Schema Change Request

Document ID	Change Request Number 18
Change Type	Enhancement
Title	Non PTS FRC Services
Date	2 February, 2005
Prepared By	Andrew Screen
Priority	Low

Figure 2-1 GasMasterStandingData

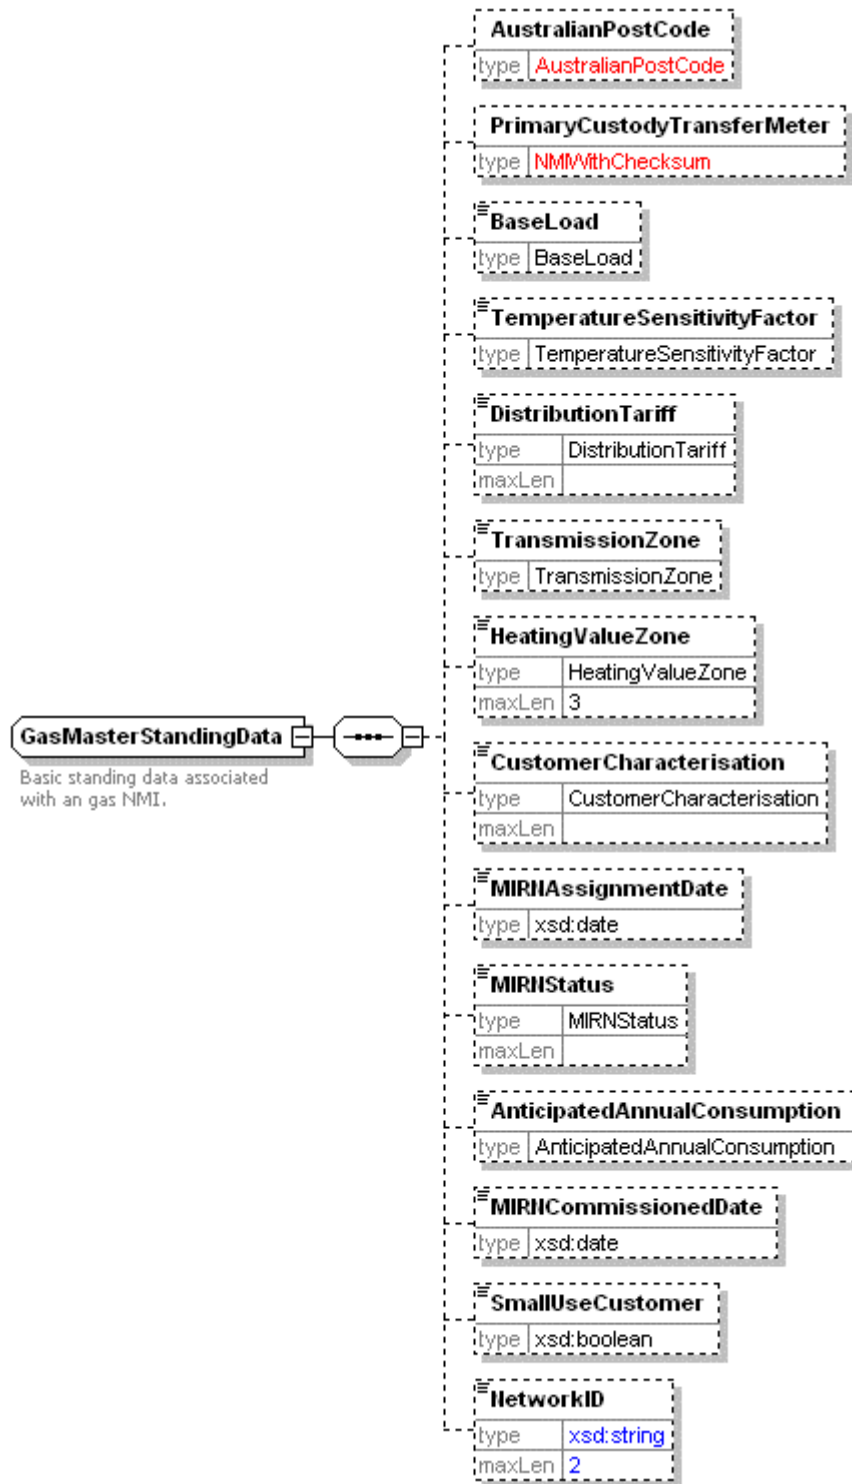
Optional Element NetworkID is added to GasMasterStanding data
